## **CITY OF ISSAQUAH DEVELOPMENT COMMISSION**

### **STAFF REPORT**

Site Development Permit SDP17-00003  
March 23, 2018

**ISSAQUAH LOFTS**  
160 Northwest Gilman Boulevard

Figure 8. Pedestrian perspective.

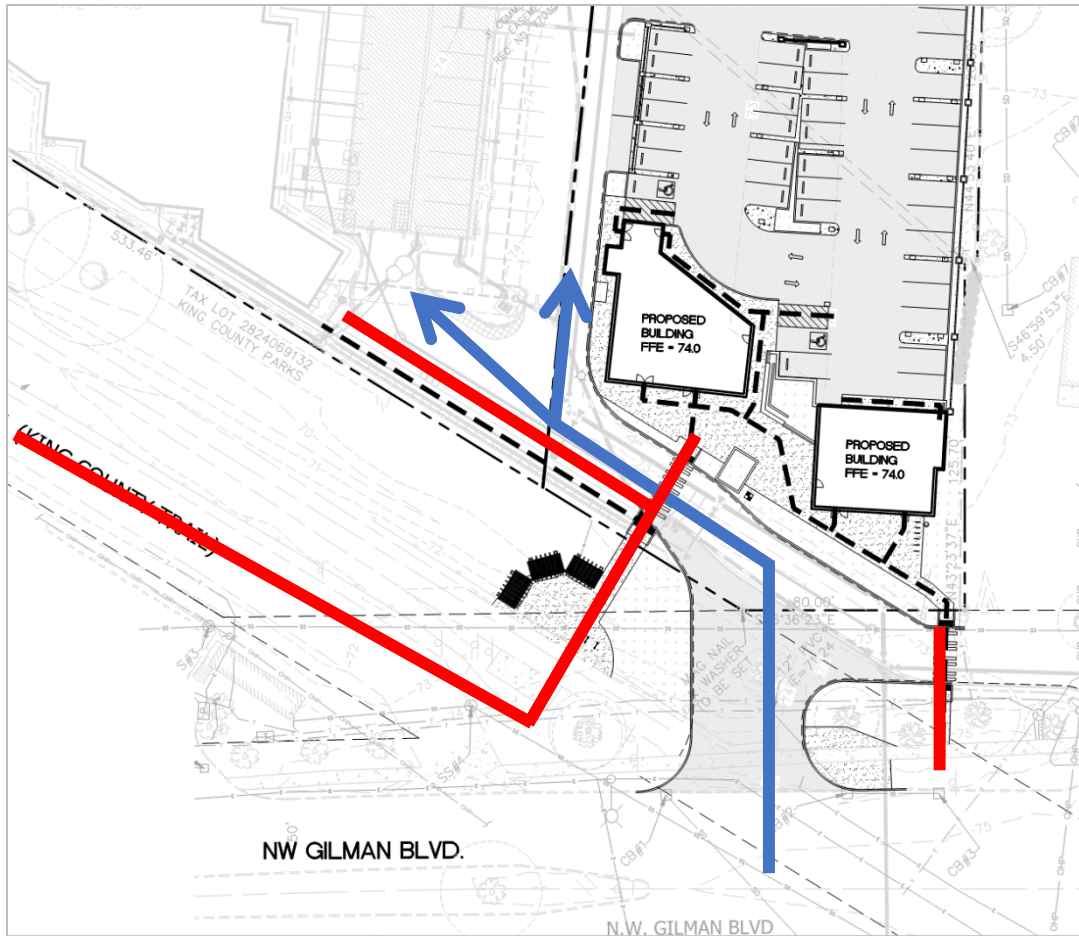
As submitted, the project plans depict a pedestrian circulation system. The site has a direct, clear and predictable circulation route, both for pedestrians and vehicles. The building entries are easily identified by the weather protection over the street-facing primary entrances of the first-floor retail

spaces. To ensure compliance with all pedestrian circulation requirements, a pedestrian circulation system would be provided to the City with submittal of the construction permit applications. The pedestrian circulation system must clearly demonstrate connections between the storage building, the studio lofts building, and the adjacent streets. All pedestrian circulation facilities shall be a minimum of 6 feet in width, clear of intrusions, including bollards, handrails, railings, and so forth [Condition 6].

- 6 All pedestrian circulation facilities shall provide a minimum width based on the CIDDS standards, clear of intrusions, including bollards, handrails, railings, mature plantings, and so forth.

Figure 13. Architectural rendering of the under-building parking from the Pogacha parking lot, adjacent to I-90.

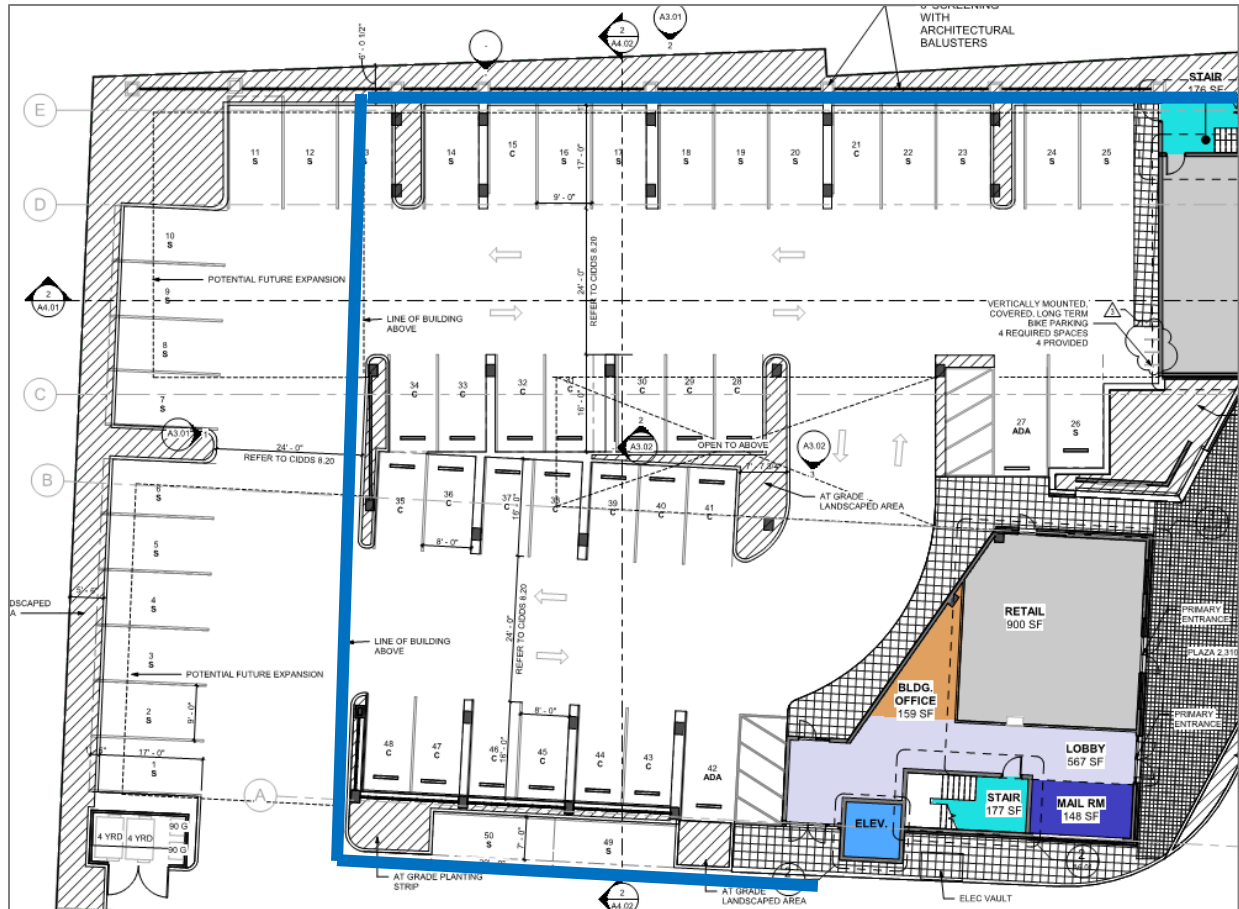
The roofline of the building is depicted in blue in Figure 12. Figures 12 and 13 have been provided to demonstrate that a large portion of the onsite parking is located under the building. The proposed parking plan constitutes as Structured Parking, and is therefore consistent with the Central Issaquah Plan's vision for a reduction in the use of surface parking. The surface parking portion is screened from the outdoor community spaces by the building. Staff is working with the applicant to address tree and landscaping requirements; as of now, the proposed landscaping is deficient in sufficient detail to adequately assess whether the landscaping requirements have been met. The surface parking lot would be softened with the required 10 percent internal landscaping and provision of one tree for every six parking spaces per Chapter 10.5. Additionally, the applicant shall provide plans, to be reviewed with the construction permits, that demonstrate compliance with Chapter 15.3 **[Condition 13]**.

- 13 The surface parking lot shall be softened with the required 10 percent landscaping and provision of one tree for every six parking spaces. If ten percent internal parking lot landscaping is not provided, architectural parking lot edge treatments shall be utilized per CIDDs 10.5. Additionally, the applicant shall provide plans, to be reviewed with the construction permits, that demonstrate compliance with Chapter 15.3. This will be verified with the review of Site Work and Landscape permits.
